UNITED STATES
NUCLEAR REGULATORY COMMISSION

ADVISORY COMMITTEE ON NUCLEAR WASTE
WASHINGTON, D.C. 20555-0001

**SUBJECT: COMMENTS ON THE IMPORTANCE OF CHEMISTRY IN THE NEAR FIELD
TO DOE's YUCCA MOUNTAIN REPOSITORY LICENSE APPLICATION**

CHEMISTRY IN THE PROPOSED YUCCA MOUNTAIN REPOSITORY NEAR FIELD

Figure 1. Waste Package and Drift Design Cross Section

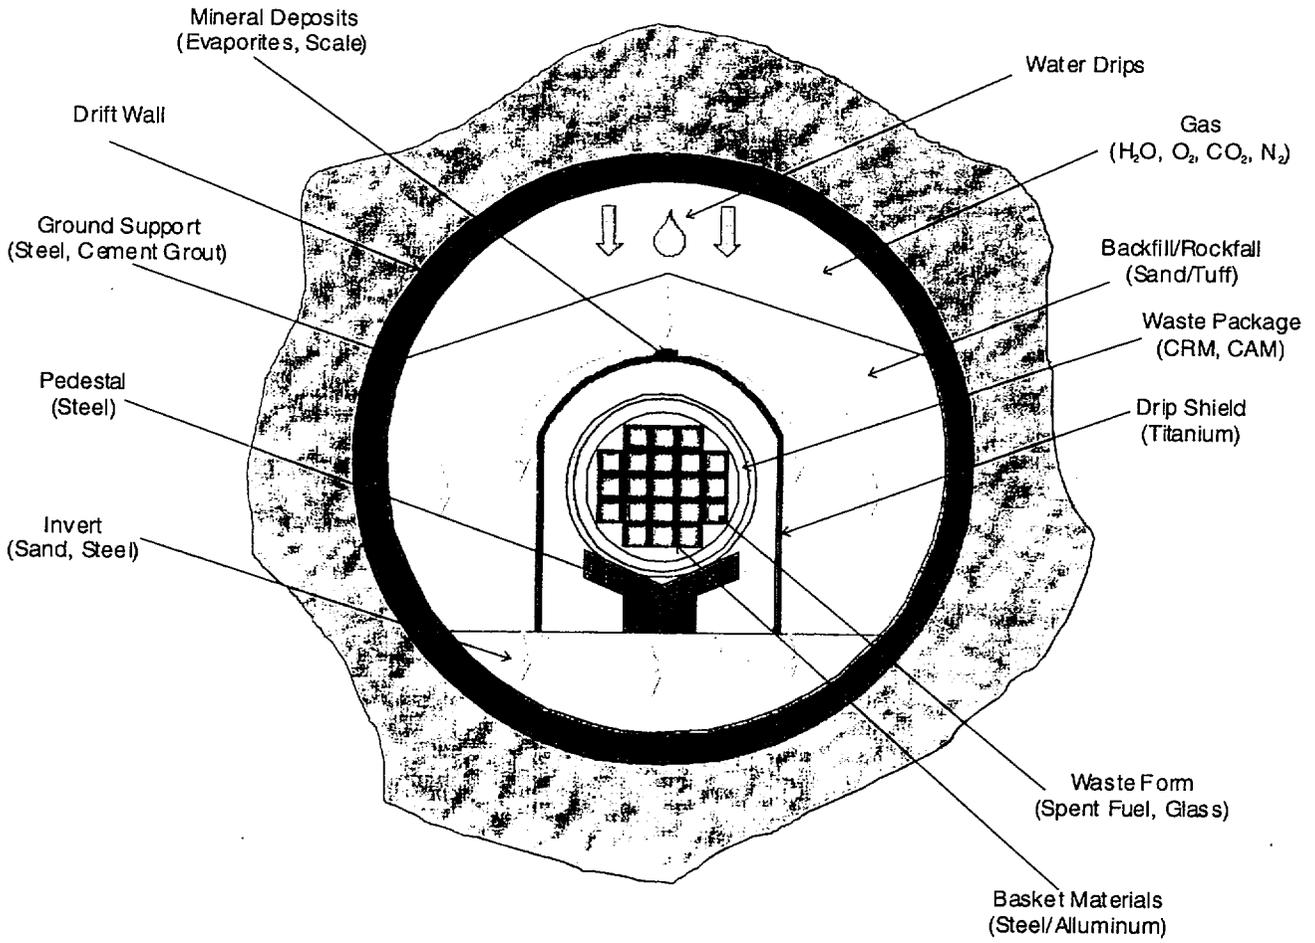
The current waste package design is shown in cross section Figure 1. The outer container has a 2 centimeter-thick wall of alloy C-22, whose composition is given in table 3. The inner container has a 5 centimeter-thick wall of stainless steel. It is expected that the stainless steel will corrode much faster than the C-22 once water breaches the C-22, and that in times far shorter than the repository licensing period it will be completely oxidized provided that the C-22 is in fact breached. As noted above, this steel could produce locally reducing conditions in the waste package or drift, and if oxidized, will add to the ionic iron content of the water. (Iron corrosion products would occupy more volume than the stainless steel from which they come, leading to potential adverse mechanical and structural effects. However, these effects are not considered here.) Unlike the steel in the waste package support and the steel invert, the iron ions from the stainless steel in the waste package container will be available for chemical reactions with the waste form itself at the water-waste interface.
